6 SUB2012-00034

STONE'S SUBDIVISION, RE-SUBDIVISION OF LOT 1

DETAIL SITE PLAN

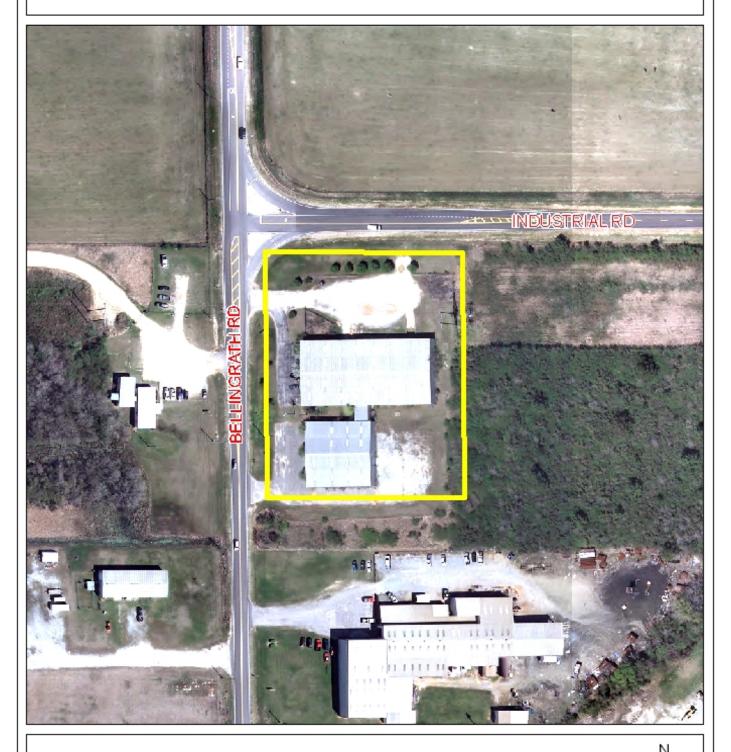
The site has frontage along Bellingrath Road and Industrial Road, both of which are major streets on the Major Street Plan, and as such, both should have a 100' right-of-way. The recorded subdivision plat illustrates a 60' right-of-way along Bellingrath Road and does not depict Industrial Road at all. The preliminary plat submitted does not give a right-of-way width for Industrial Road, and states that the right-of-way for Bellingrath Road varies. If approved, the Final Plat should be revised to depict a 100' right of way for both roads, with any dedications necessary to provide 50' from the centerline. Also, dedication of curb radii at the intersection in compliance with Section V.B.16. of the Subdivision Regulations should be illustrated as well.

The lot sizes are not labeled in square feet or acres on the preliminary plat. This information should be placed on the Final Plat, if approved.

The proposed lots are labeled as "1-A" and "1-B", and if approved, they should be re-labeled as "Lot 1" and "Lot 2" or "Lot A" and "Lot B".

The 25-foot minimum building setback is not shown on the preliminary plat as required by Section V.D.9. of the Subdivision Regulations. If approved, the minimum building setback line should be depicted on the Final Plat.

- 1) depiction of the 25-foot minimum building setback line along Bellingrath Road and Industrial Road, as required by Section V.D.9. of the Subdivision Regulations;

- 2) labeling of the lot sizes, in square feet and acres, or provision of a table on the Final Plat with the same information;
- 3) re-label lots as "Lot 1 and "Lot 2" or "Lot A" and "Lot B";

- 4) dedications to provide 50' from the centerline along both Bellingrath Road and Industrial Road if necessary;
- 5) dedications to provide curb radii at the intersection in compliance with Section V.B.16. of the Subdivision Regulations;
